SSPD8 - ENGINE TEMPERATURE AND HEATER PERFORMANCE CONCERNS WITH OR WITHOUT DTC P0126:00

Updated 1/30/2026:

WARRANTY EXTENSION

REPAIR PROCEDURE – FLOW CHART

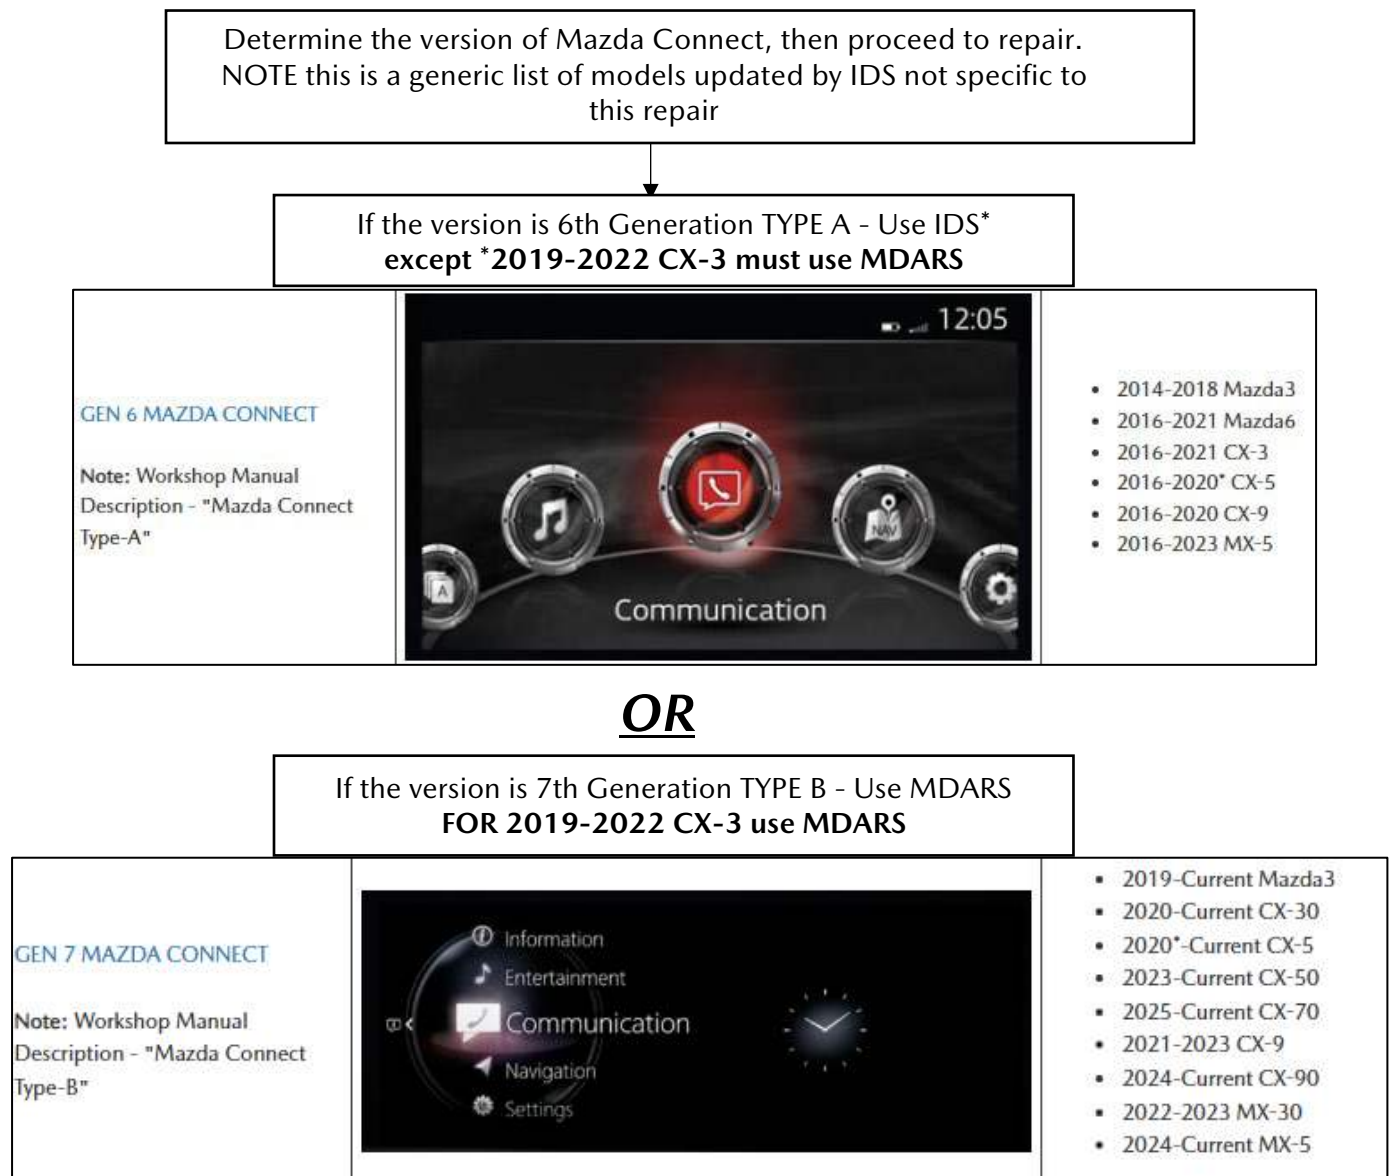
Section A: Flow Chart: **NOTE: This Flow Chart needs to be followed strictly.**

The dummy plug and PCM update repair procedure are required as of December 8, 2025. The TSB has been updated to repair with the dummy plug and PCM update here: [6](#).
